**AGENDA OF THE CITY COUNCIL MEETING
FOR THE CITY OF HAYDEN, KOOTENAI COUNTY, IDAHO**

Agenda Item: Authorize Change Order No. 5 with LaRiviere, Inc. for the Honeysuckle Avenue and Ramsey Road Roundabout Project for changes related to private utility delays and conflicts, pedestrian access revisions, a deductive adjustment for water facility testing, a deductive adjustment for resident project representative costs for Saturday work, and a time adjustment to ensure that added contract days fall on working days for a net cost decrease of \$6,108.43 and twelve (12) added contract days.

CONTRACT CHANGE ORDER NO. 5

CONTRACT CHANGE ORDER NO. 5
TO
41014.14 - HONEYSUCKLE AVENUE AND RAMSEY ROAD ROUNDABOUT IMPROVEMENTS

PRELIMINARY – NOT FOR CONSTRUCTION

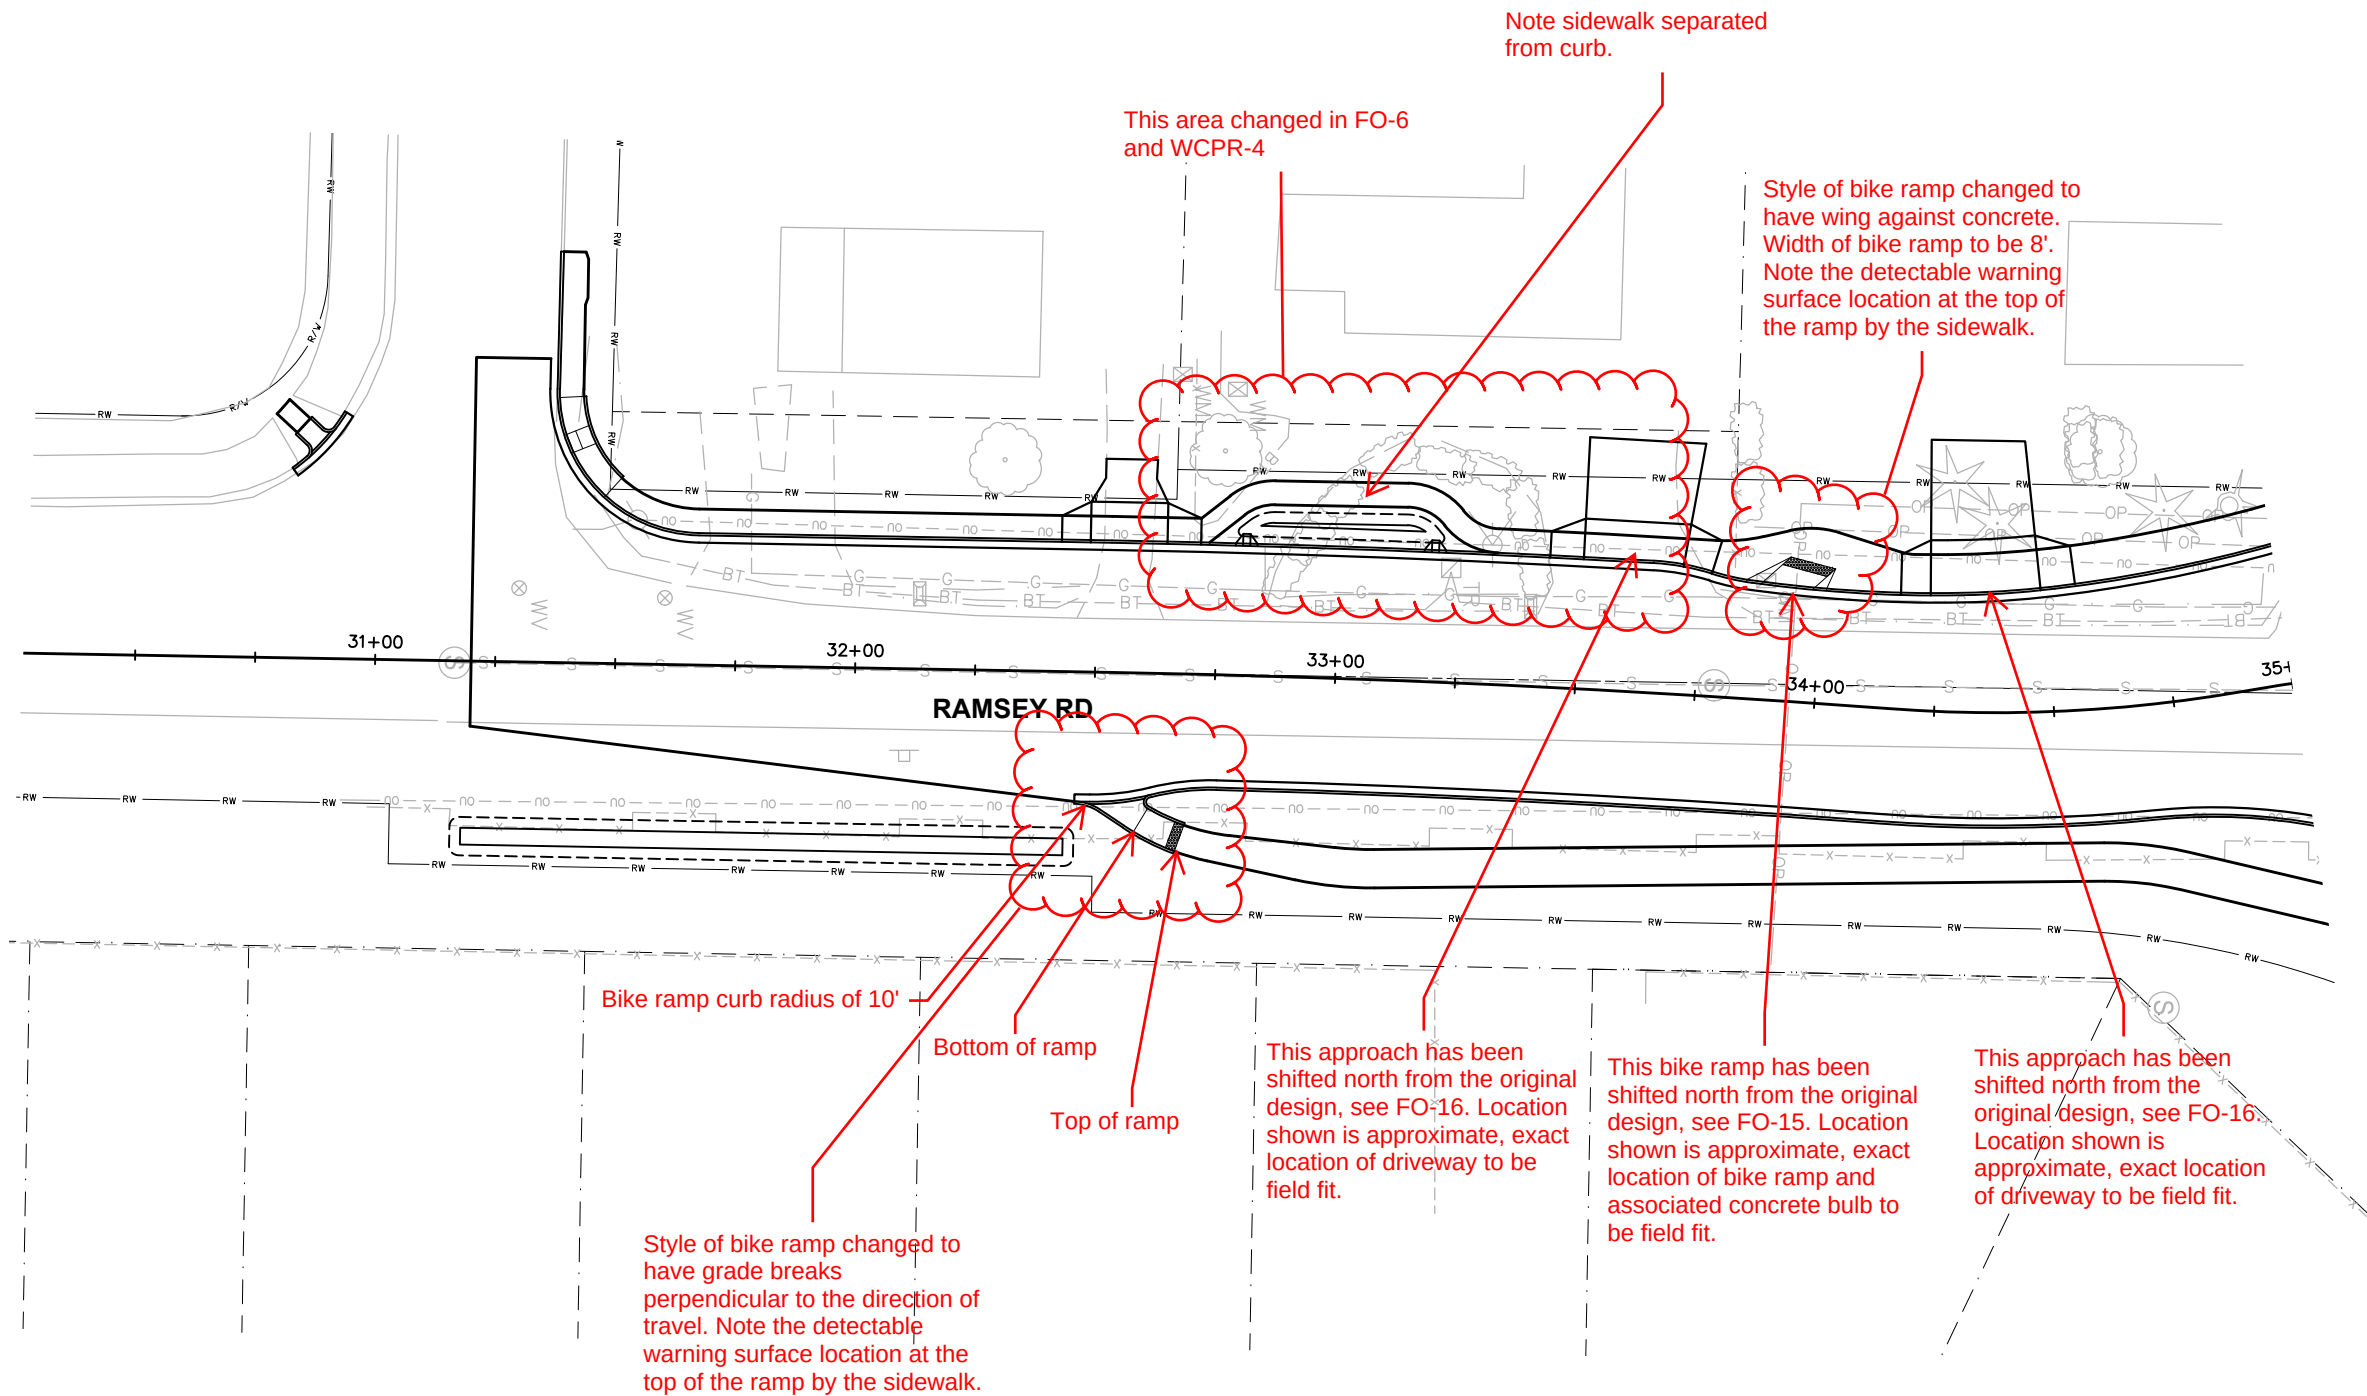
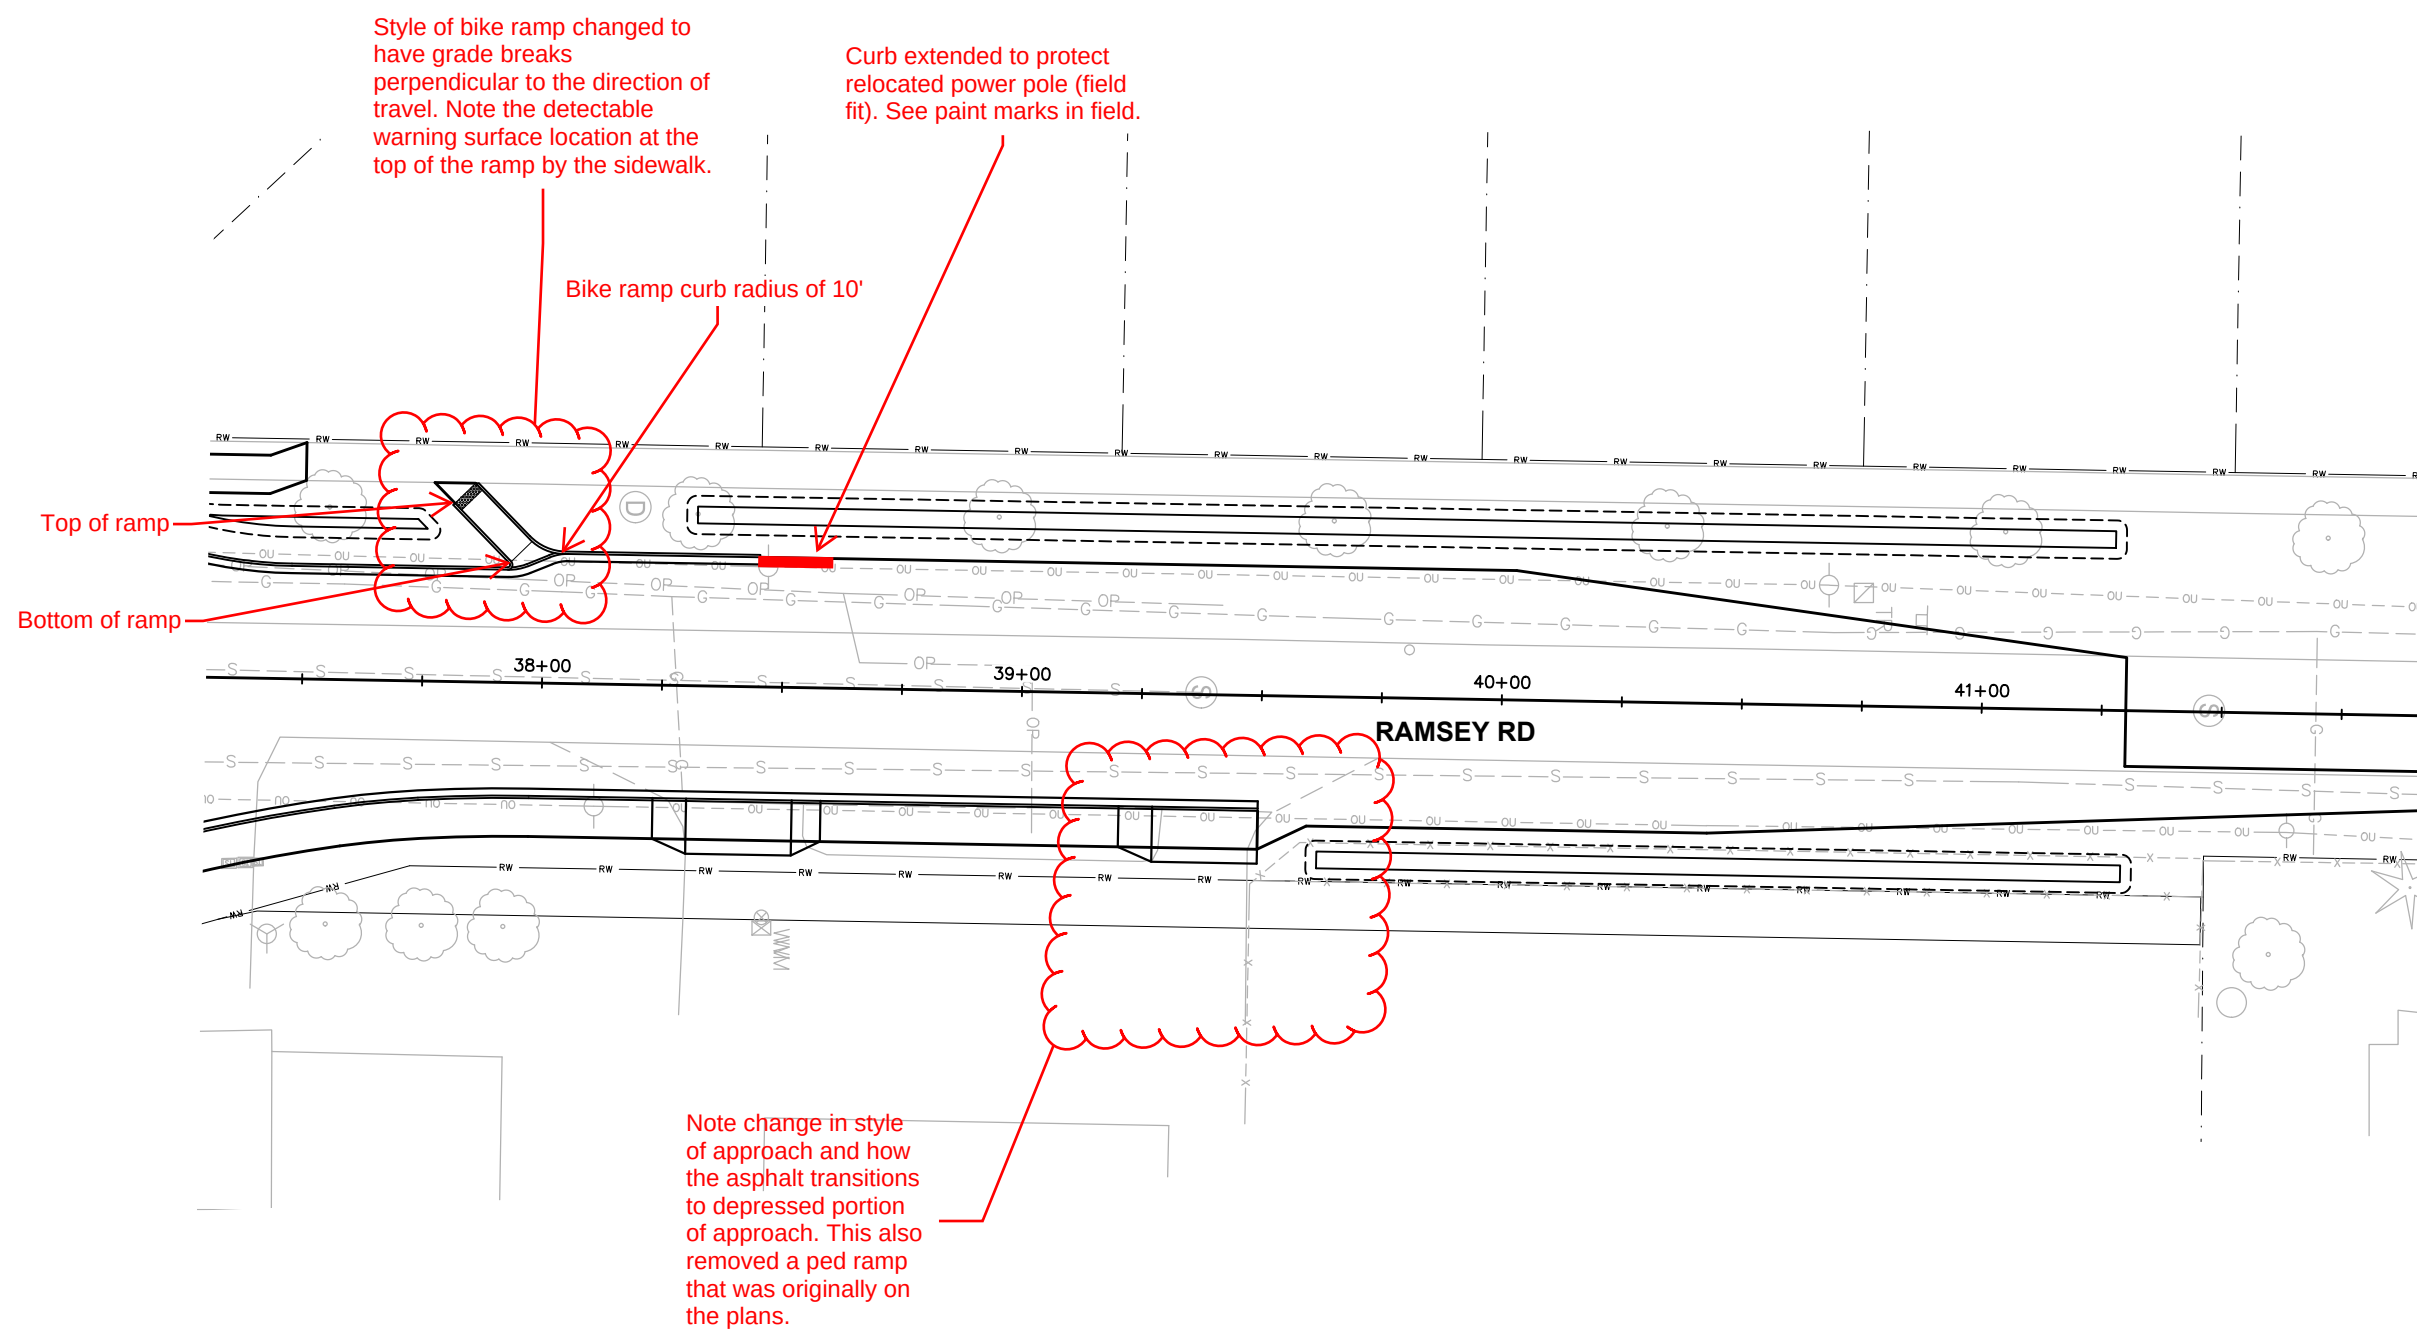
Refer to attached exhibits for modifications to ped ramp style, approach style, and adjustments to sidewalk. Any adjustments to quantities will be noted and paid at unit cost.

- Honeysuckle/Ramsey Intersection Plan View Exhibits (Four Sheets – West, East, South, and North Leg)
- Bike Ramp Detail

Drainage and Landscape Plan
Honeysuckle Avenue & Ramsey Road
Roundabout Improvements
City of Hayden, Idaho

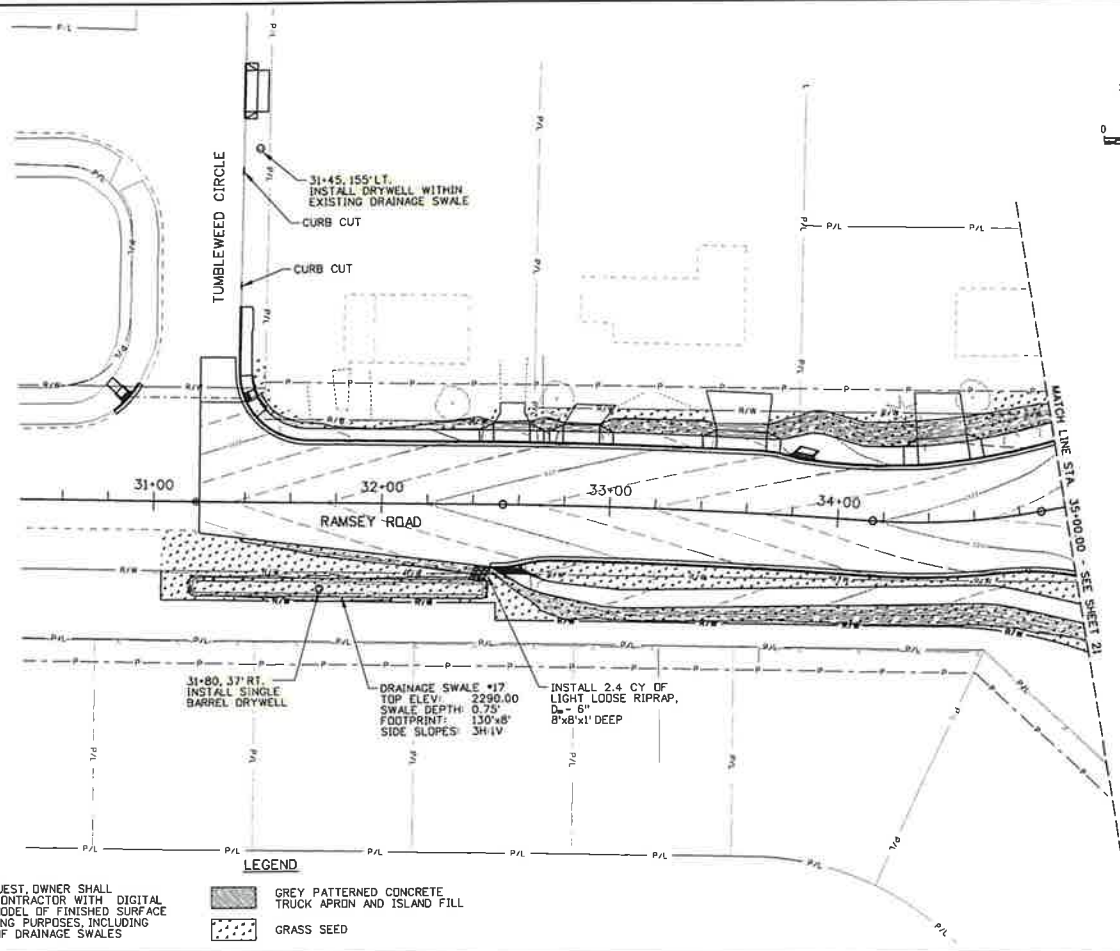
- **Sheet 23 of 44**, Sta. 31+45 LT. This dry well location has power Fiber conflicts, Request force account to be tracked exposing these lines and field fitting the structure.

- Sta. 31+80 RT. This location appears to be ok for utility conflicts and installation. TBD.

SHEET NO. 24

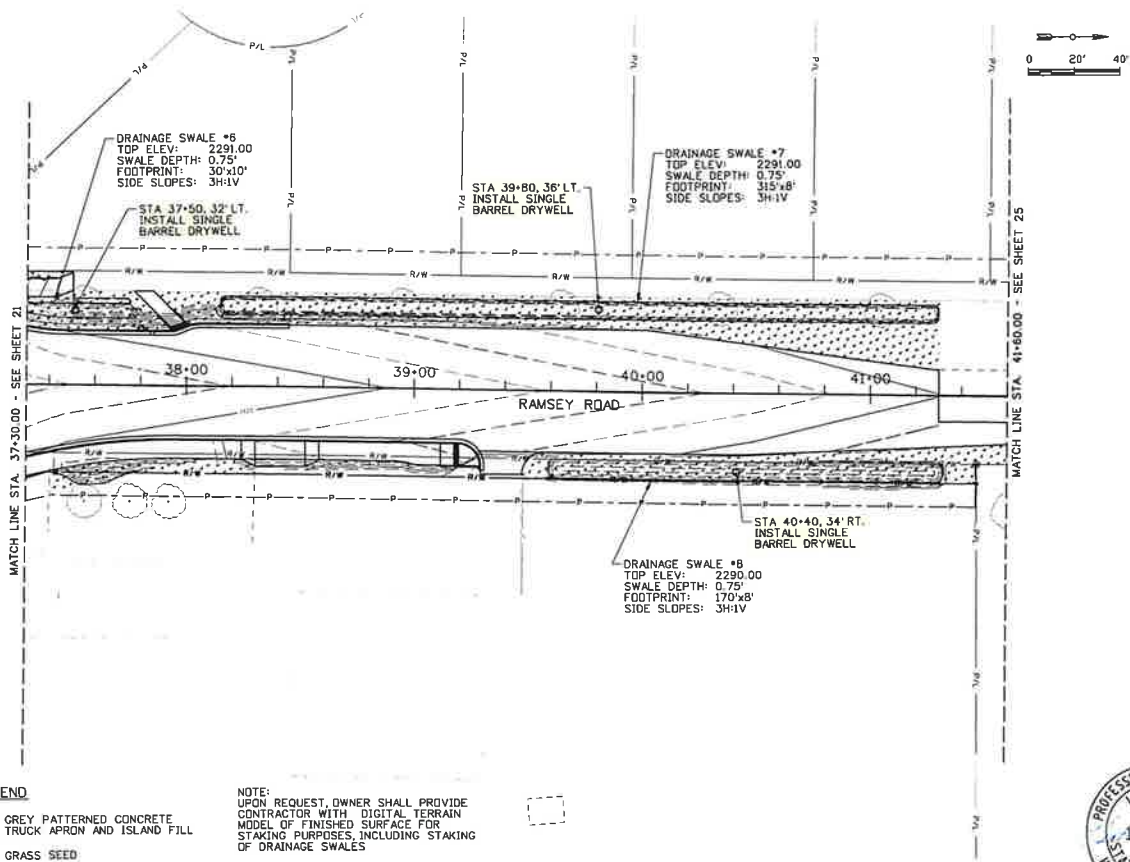
- **Sheet 24 of 44,** Sta 37+50 LT, Tree, Fiber, Power conflicts with current location not shown on the plans. Field fit will be required. Request force account to be tracked while doing so.
- Sta 38+80 LT. Tree, Fiber, Power conflicts with current location not shown on the plans. Field fit will be required. Request force account to be tracked while doing so.
- Sta. 40+40 RT. Fiber and Power in this area. Conflict to be determined, Force account work for locating and field fitting may be needed.
